Access Compliance Report

Public Rights-of-Way

Intersection ID: 10037035	Main Street: S_TRYON_ST	Cross Street: N/A	Location: S
ADA ID: 6A5B25CFF753	Ramp Type: Perp	Initial Pass/Fail: Fail	Overall Compliance: No
		Severity Score: 12.5

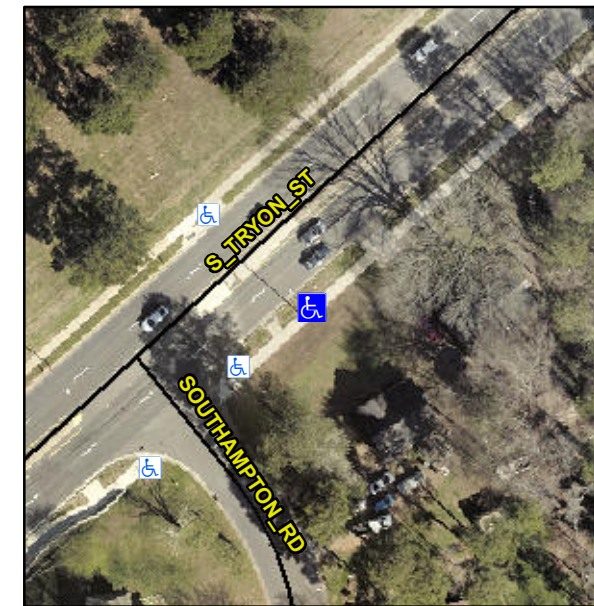
R304.2.2

Compliance	Description	Data	Compliance	Description	Data
N/A	Ramp Length (in)	101.0	No	Ramp Slope (%)	8.7
Yes	Ramp Width (in)	72.0	Yes	Ramp XSlope (%)	1.5
N/A	Flare Type LT	N/A	N/A	Flare Type RT	N/A
N/A	Flare Slope LT (%)	N/A	N/A	Flare Slope RT (%)	N/A
N/A	Flare Traversable LT?	N/A	N/A	Flare Traversable RT?	N/A
N/A	Landing Length (in)	N/A	N/A	DWS Provided?	N/A
N/A	Landing Width (in)	N/A	N/A	DWS Contrast?	N/A
N/A	Landing Slope (%)	N/A	N/A	DWS Length (in)	N/A
N/A	Landing X Slope (%)	N/A	N/A	DWS Full Width?	N/A
N/A	Landing Curb? (Y/N)	N/A	N/A	DWS Offset (in)	N/A
N/A	Shared Landing?	N/A			
N/A	Gutter Ponding?	N/A	N/A	Gutter Slope (%)	N/A
N/A	Gutter Lip Ht (in)	N/A	N/A	Gutter X Slope (%)	N/A
N/A	Painted X Walk1?	No	N/A	Painted X Walk2?	N/A
	X Walk 1 Direction	To NW		X Walk 2 Direction	N/A
N/A	X Walk 1 Width (in)	N/A	N/A	X Walk 2 Width (in)	N/A
	X Walk 1 Slope (%)	1.4		X Walk 2 Slope (%)	N/A
	X Walk 1 X Slope (%)	2.7		X Walk 2 X Slope (%)	N/A

Remove & Replace Entire Ramp.
